Value Engineering Study Report

Campbellsville Bypass

Kentucky Transportation Cabinet

Item Nos: 4-142.20 and 4-142.30

Figure 9-2

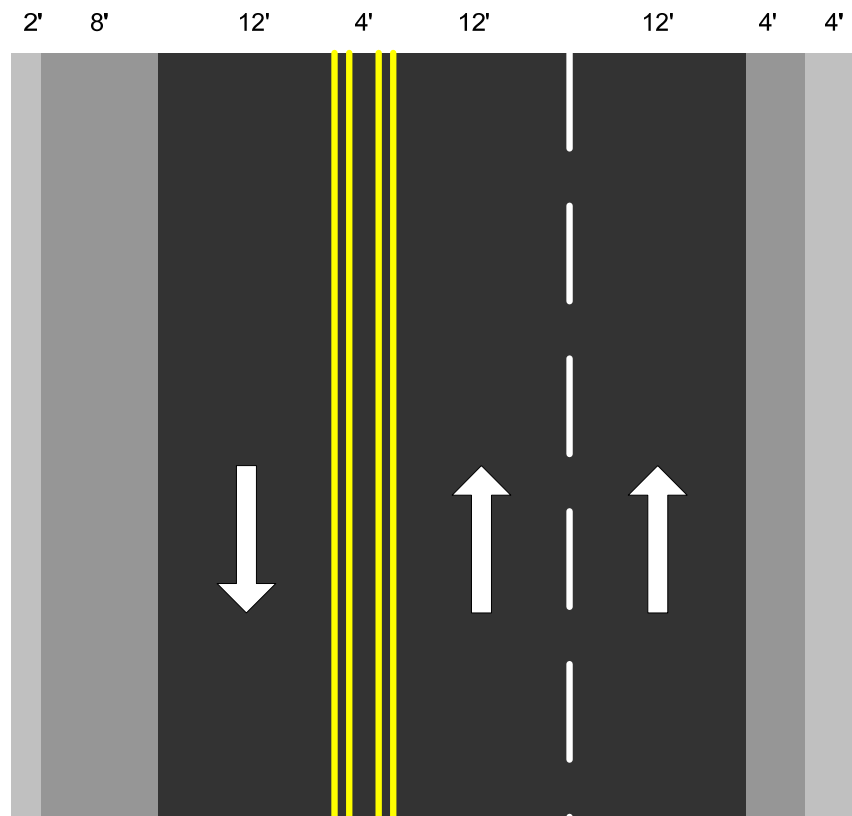
It was assumed that no additional right-of-way would be needed compared to the original design. There would need to be an additional 12 feet of pavement compared to the initial 2-lane construction. The design team would need to decide whether to leave this in place and modify (shift) the ultimate additional two lanes, or to take out the 12 feet of width and keep the original 4-lane alignment.

For development of this recommendation, the typical section was assumed to have three 12-foot travel lanes and a 4-foot flush median. Shoulders are 8' paved in one direction and 4' the other. The structures would be widened 16 feet to accommodate the passing lane and median. The project team has the option to reduce the cross section, such as reducing the shoulder widths, to reduce construction costs.
